Access Compliance Report

Public Rights-of-Way

(Curb Ramps)

Intersection ID: 18038	Main Street: INWOOD_DR	Cross Street: MURRAYHILL_RD	Location: SW
ADA ID: DE410CBE939C	Ramp Type: Directional1	Initial Pass/Fail: Pass	Overall Compliance: No
Severity Score: 17.75			
Codes/Mitigation Info/Possible Solution		Field Measurements/Component Compliance

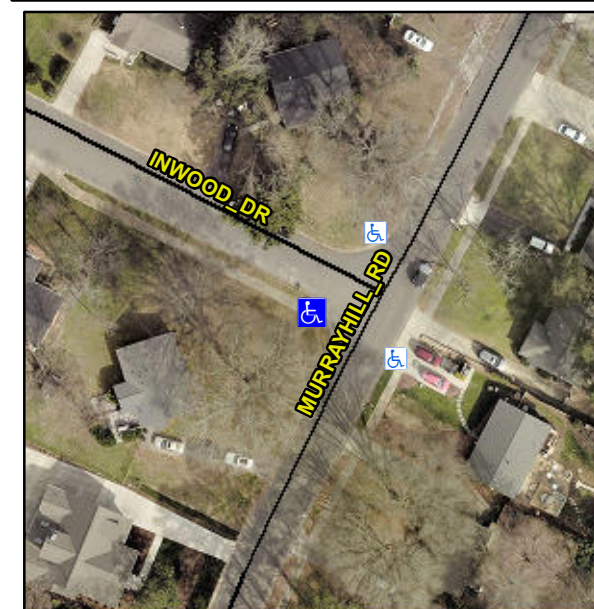
**R304.5.3, R304.2.2-Perp, R304.3.2-
Para, R305.1.4, R305.2, R302.7.2**

Compliance	Description	Data	Compliance	Description	Data
N/A	Ramp Length (in)	36.0	Yes	Grade Break?	Yes
Yes	Ramp Width (in)	70.0	Yes	Grade Break Slope (%)	2.6
Yes	Ramp Slope (%)	6.1	Yes	Grade Break XSlope (%)	0.7
No	Ramp XSlope (%)	2.7			
N/A	Flare Type LT	N/A	N/A	Flare Type RT	N/A
N/A	Flare Slope LT (%)	N/A	N/A	Flare Slope RT (%)	N/A
N/A	Flare Traversable LT?	N/A	N/A	Flare Traversable RT?	N/A
Yes	Landing Length (in)	48.0	Yes	DWS Provided?	Yes
Yes	Landing Width (in)	70.0	Yes	DWS Contrast?	Yes
No	Landing Slope (%)	2.9	Yes	DWS Length (in)	24.0
No	Landing X Slope (%)	2.6	No	DWS Full Width?	No
N/A	Landing Curb? (Y/N)	N/A	No	DWS Offset LT (in)	85.0
N/A	Shared Landing?	No	No	DWS Offset RT (in)	27.0
Yes	Gutter Ponding?	No	Yes	Gutter Slope (%)	2.8
No	Gutter Lip Ht (in)	1.0	Yes	Gutter X Slope (%)	0.2
N/A	Painted X Walk1?	No		Road Slope (%)	0.6
	X Walk 1 Direction	To E		Road X Slope (%)	0.8
	X Walk 1 Width (in)	N/A		Clear Space?	Yes

X Walk 1 Slope (%)	0.6	N/A	Clear Space to XWalk (in)	N/A
	X Walk 1 X Slope (%)	0.8	Yes	Storm Grate/Utility Hazard?	No
N/A	Ramp inside XWalk1?	N/A		Storm Grate/Utility Type	
Yes	Any Obstructions?	No			N/A
	Obstruction Type		Yes	Surface Condition? (G/P)	Good
			N/A	Curb Slope (%)	19.5

**Remove & Replace Entire Ramp.
Grind Gutter Lip.**
